ADDENDUM NO. 1

October 13, 2021

UNION DECK ELEVATOR REPLACEMENT
UNC CHARLOTTE

WHN PROJECT NO. 20142 | SCO ID NO. 20-2231

2 ELECTRICAL NEW WORK - SECOND FLOOR
 E201 SCALE: 1/4"=1'-0"

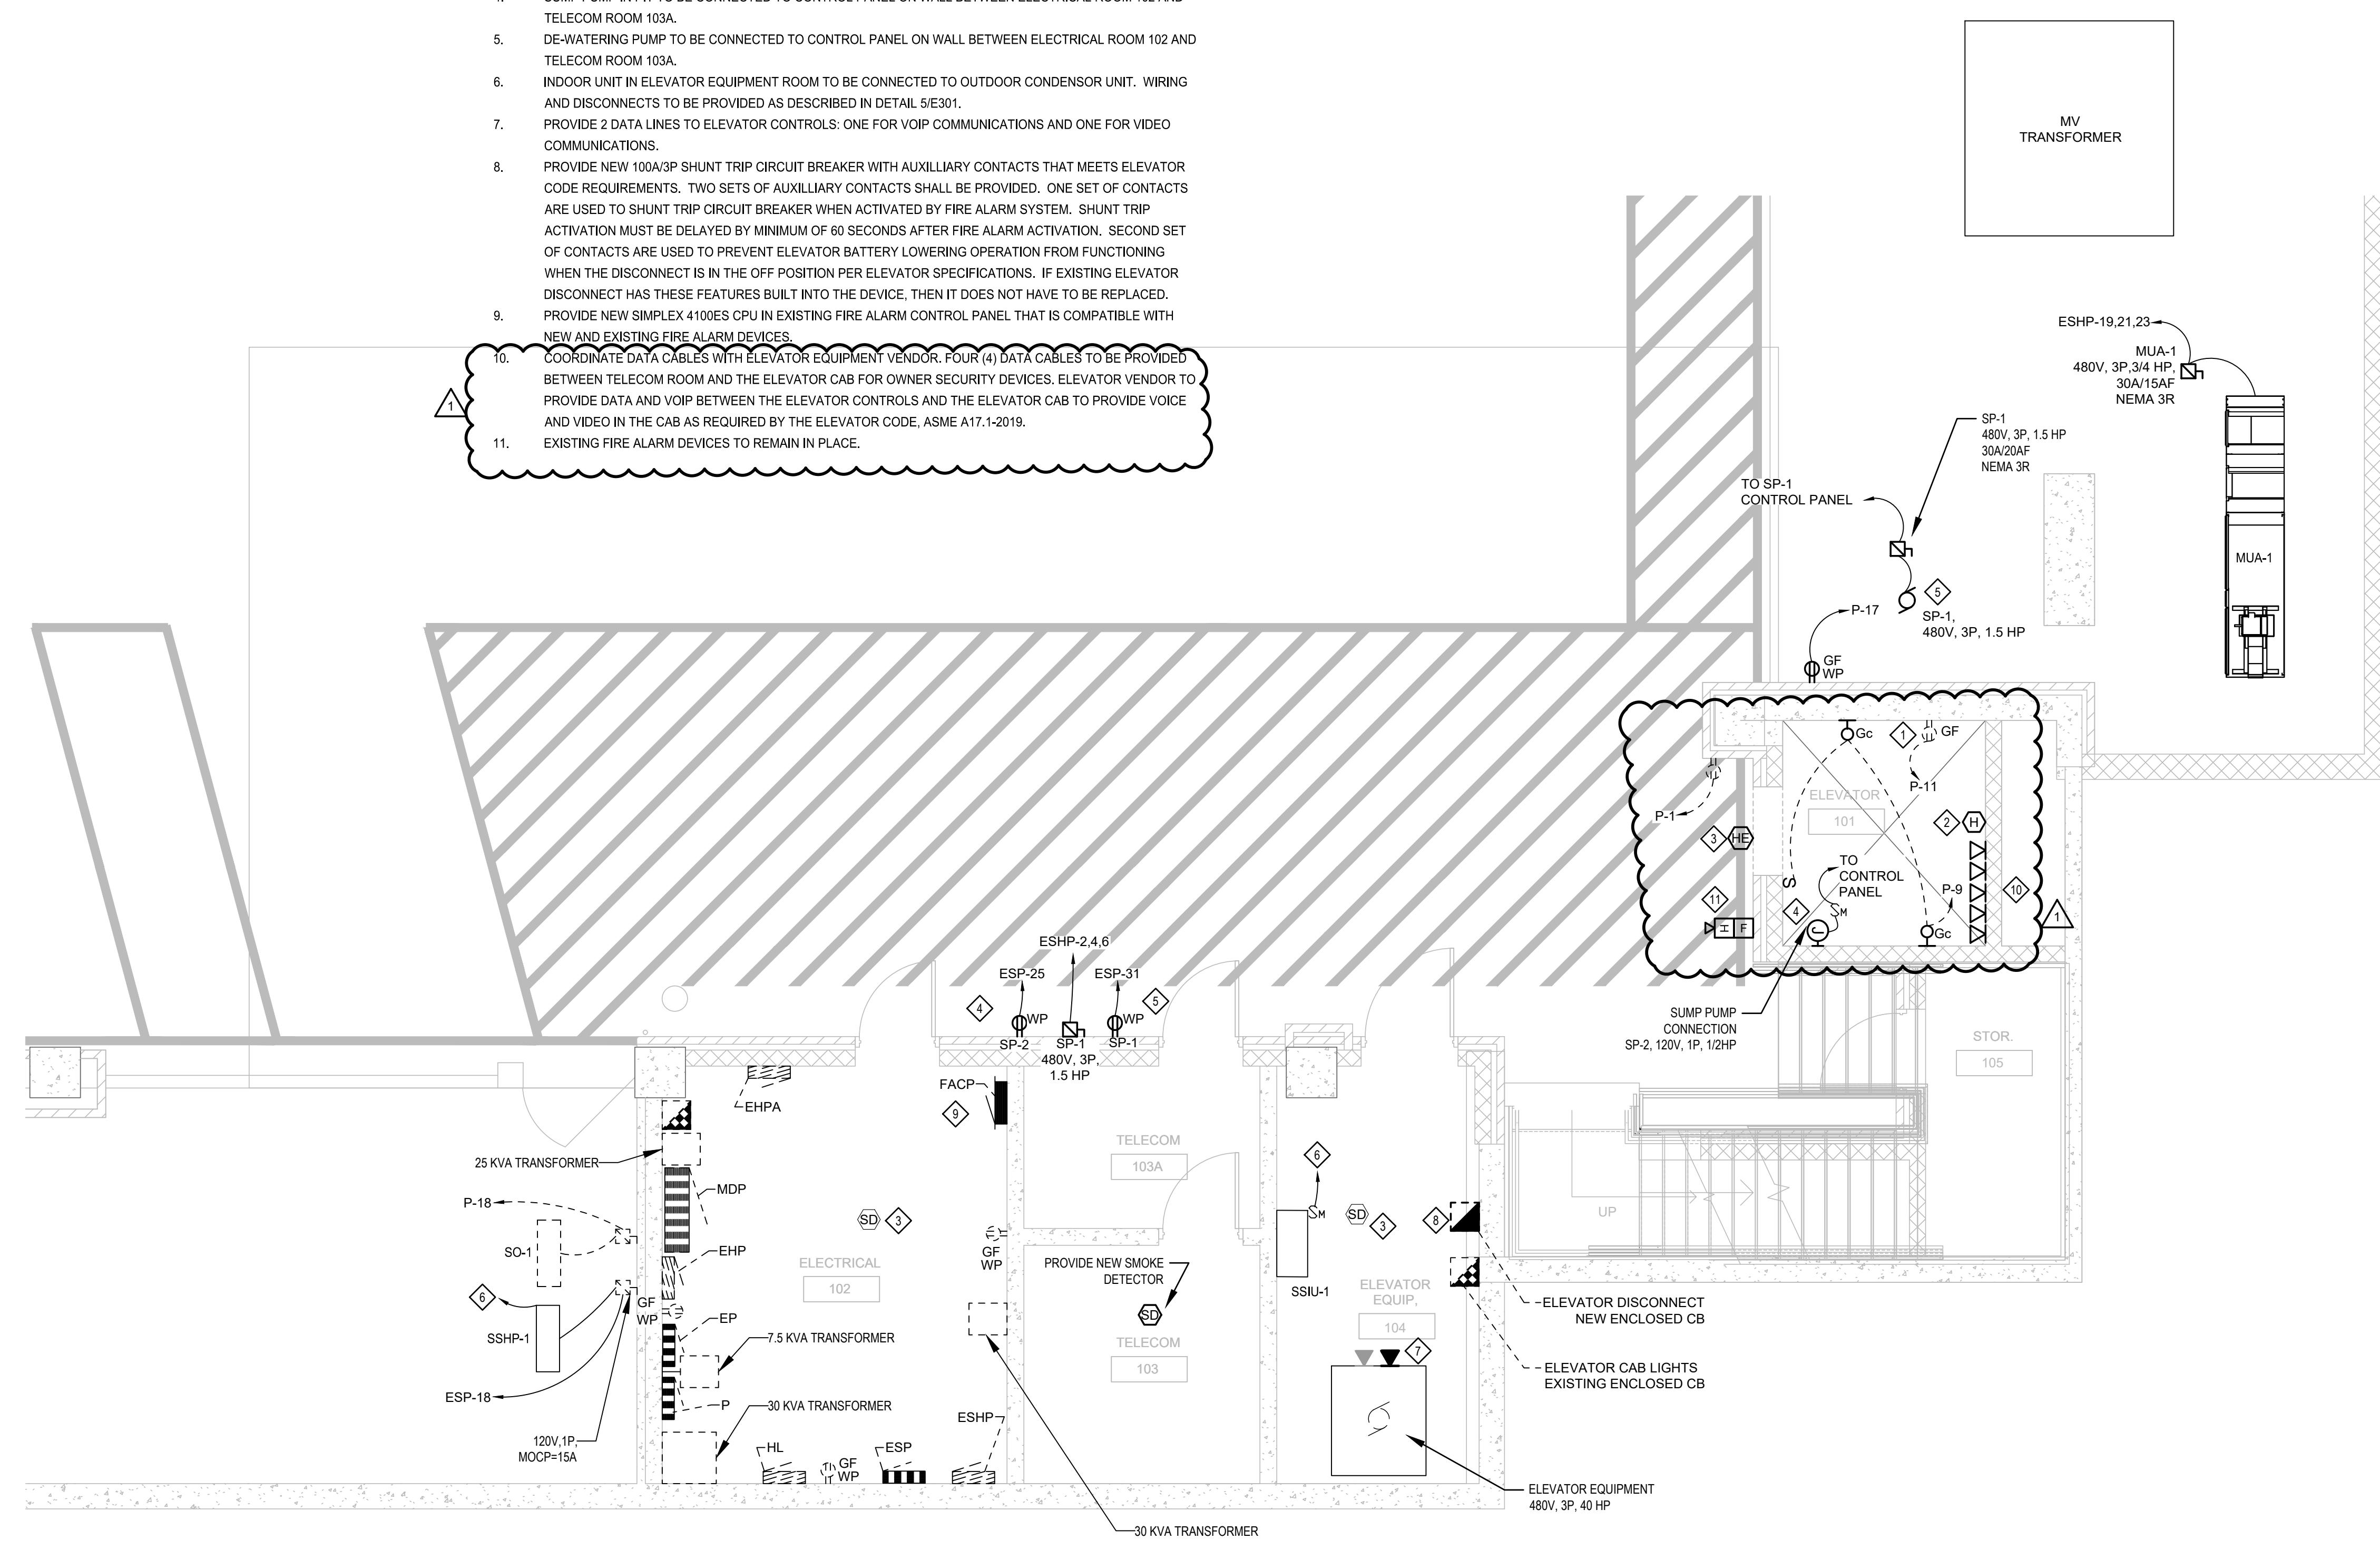
- CONFIRM EXISTING RECEPTACLE IS A GFI TYPE OR PROVIDE NEW GFI RECEPTACLE.
- PROVIDE NEW HEAT DETECTOR MOUNT IN PLINTH ABOVE PIT FLOOR.
- PROVIDE NEW HEAT DETECTOR FOR ELEVATOR RECALL.

- INDOOR UNIT IN ELEVATOR EQUIPMENT ROOM TO BE CONNECTED TO OUTDOOR CONDENSOR UNIT. WIRING AND DISCONNECTS TO BE PROVIDED AS DESCRIBED IN DETAIL 5E301.

- PROVIDE 2 DATA LINES TO ELEVATOR CONTROLS: ONE FOR VOIP COMMUNICATIONS AND ONE FOR VIDEO COMMUNICATIONS.
- PROVIDE NEW 100A/3P SHUNT TRIP CIRCUIT BREAKER WITH AUXILIARY CONTACTS THAT MEETS ELEVATOR CODE REQUIREMENTS. TWO SETS OF AUXILIARY CONTACTS SHALL BE PROVIDED. ONE SET OF CONTACTS ARE USED TO SHUNT TRIP CIRCUIT BREAKER WHEN ACTIVATED BY FIRE ALARM SYSTEM. SHUNT TRIP ACTIVATION MUST BE DELAYED BY MINIMUM OF 60 SECONDS AFTER FIRE ALARM ACTIVATION. SECOND SET OF CONTACTS ARE USED TO PREVENT ELEVATOR BATTERY LOWERING OPERATION FROM FUNCTIONING WHEN THE DISCONNECT IS IN THE OFF POSITION PER ELEVATOR SPECIFICATIONS. IF EXISTING ELEVATOR DISCONNECT HAS THESE FEATURES BUILT INTO THE DEVICE, THEN IT DOES NOT HAVE TO BE REPLACED.

- PROVIDE NEW SIMPLY 410ES CPU IN EXISTING FIRE ALARM CONTROL PANEL THAT IS COMPATIBLE WITH NEW AND EXISTING FIRE ALARM DEVICES.
- COORDINATE DATA CABLES WITH ELEVATOR EQUIPMENT VENDOR. FOUR (4) DATA CABLES TO BE PROVIDED BETWEEN TELECOM ROOM AND THE ELEVATOR CAB FOR OWNER SECURITY DEVICES. ELEVATOR VENDOR TO PROVIDE DATA AND VOIP BETWEEN THE ELEVATOR CONTROLS AND THE ELEVATOR CAB TO PROVIDE VOICE AND VIDEO IN THE CAB AS REQUIRED BY THE ELEVATOR CODE, ASME A17.1-2019.

- EXISTING FIRE ALARM DEVICES TO REMAIN IN PLACE.
